#3 SUB2016-00043

FISHER TRACT SUBDIVISION, RESUBDIVISION OF THE NORTH 60 FEET OF LOTS 17 & 18, BLOCK 19

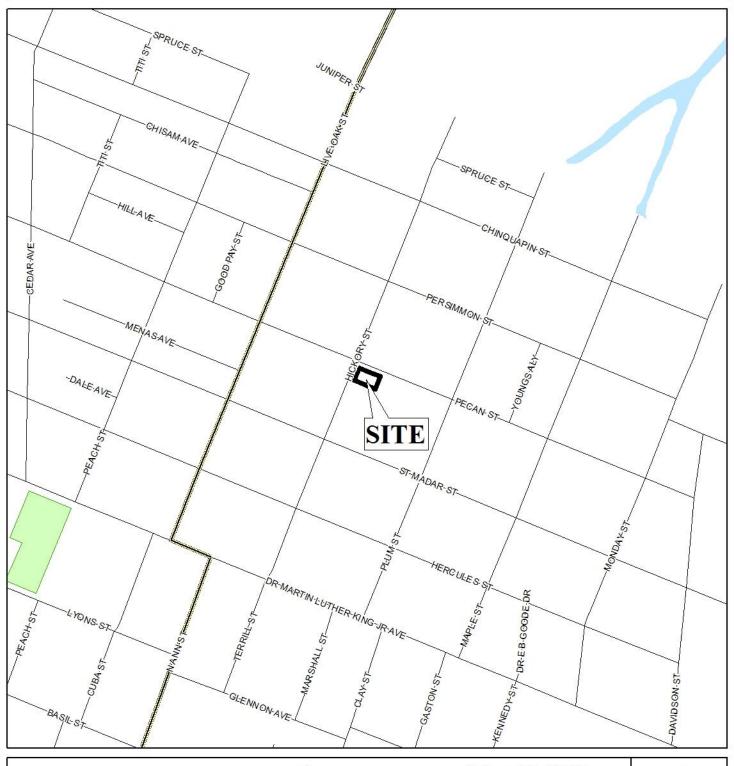
- B. Dedicate the corner radius (25' minimum or as approved by the City Engineer and Traffic Engineer) at the Northwest corner of LOT 1.
- C. Provide the Surveyor's, Owner's (notarized), Planning Commission, and Traffic Engineering signatures.

dedications necessary. However, dedication of the corner radii at Hickory Street and Pecan Street per Section V.D.6. of the Subdivision Regulations should be required.

The site received approval at the Board of Zoning Adjustment's April 4, 2016 meeting for reduced setbacks along the street frontages; a 12.5' setback along Hickory Street and a 10' setback along Pecan Street. These reduced setbacks are illustrated on the preliminary plat, and are subject to the applicant completing the Subdivision application at hand. The 25-foot minimum building setback line, required in Section V.D.9., is not shown on the preliminary plat due to the aforementioned variance, therefore a waiver of Section V.D.9. of the Subdivision Regulations would be appropriate.

The proposed lot size is provided in square feet, and would not meet the minimum required lot size of 7,200 square feet in Section V.D.2. of the Subdivision Regulations. However, the site is in an older part of the City of Mobile, and there are several sub-standard lots in the area that have been previously approved by the Planning Commission, making a waiver of Section V.D.2. of the Subdivision Regulations appropriate.

- 1) retention of the 12.5' minimum building setback line along Hickory Street;
- 2) retention of the 10' minimum building setback line along Pecan Street;

- 3) dedication of the corner radii at Hickory Street and Pecan Street per Section V.D.6. of the Subdivision Regulations;
- 4) revision of the lot size in square feet and acres, adjusted for dedication;
